# Access Compliance Report

## Public Rights-of-Way

Intersection ID: 21548	Main Street: OLD_PROVIDENCE_RD	Cross Street: PROVIDENCE_RD	Location: SE
ADA ID: 401CF0CF9F60	Ramp Type: Perp	Initial Pass/Fail: Fail	Overall Compliance: No
Codes/Mitigation Info/Possible Solution		Field Measurements/Component Compliance	
Severity Score: 21.25

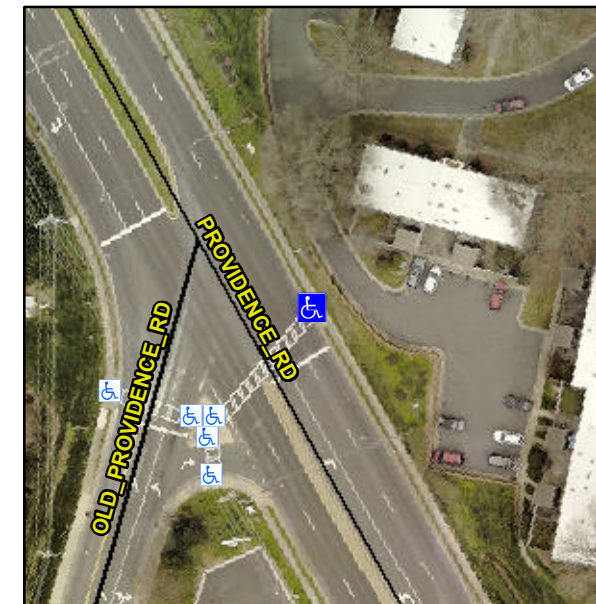
**Not Found, R304.5.1, R304.2.2**

Compliance	Description	Data	Compliance	Description	Data
N/A	Ramp Length (in)	71.0	No	Ramp Slope (%)	9.0
No	Ramp Width (in)	47.0	Yes	Ramp XSlope (%)	0.8
N/A	Flare Type LT	N/A	N/A	Flare Type RT	N/A
N/A	Flare Slope LT (%)	N/A	N/A	Flare Slope RT (%)	N/A
N/A	Flare Traversable LT?	N/A	N/A	Flare Traversable RT?	N/A
N/A	Landing Length (in)	N/A	N/A	DWS Provided?	N/A
N/A	Landing Width (in)	N/A	N/A	DWS Contrast?	N/A
N/A	Landing Slope (%)	N/A	N/A	DWS Length (in)	N/A
N/A	Landing X Slope (%)	N/A	N/A	DWS Full Width?	N/A
N/A	Landing Curb? (Y/N)	N/A	N/A	DWS Offset (in)	N/A
N/A	Shared Landing?	N/A			
N/A	Gutter Ponding?	N/A	N/A	Gutter Slope (%)	N/A
N/A	Gutter Lip Ht (in)	N/A	N/A	Gutter X Slope (%)	N/A
N/A	Painted X Walk1?	Yes	N/A	Painted X Walk2?	N/A
	X Walk 1 Direction	To SW		X Walk 2 Direction	N/A
N/A	X Walk 1 Width (in)	70.0	N/A	X Walk 2 Width (in)	N/A
	X Walk 1 Slope (%)	0.6		X Walk 2 Slope (%)	N/A
	X Walk 1 X Slope (%)	2.3		X Walk 2 X Slope (%)	N/A

**Remove & Replace Entire Ramp.**
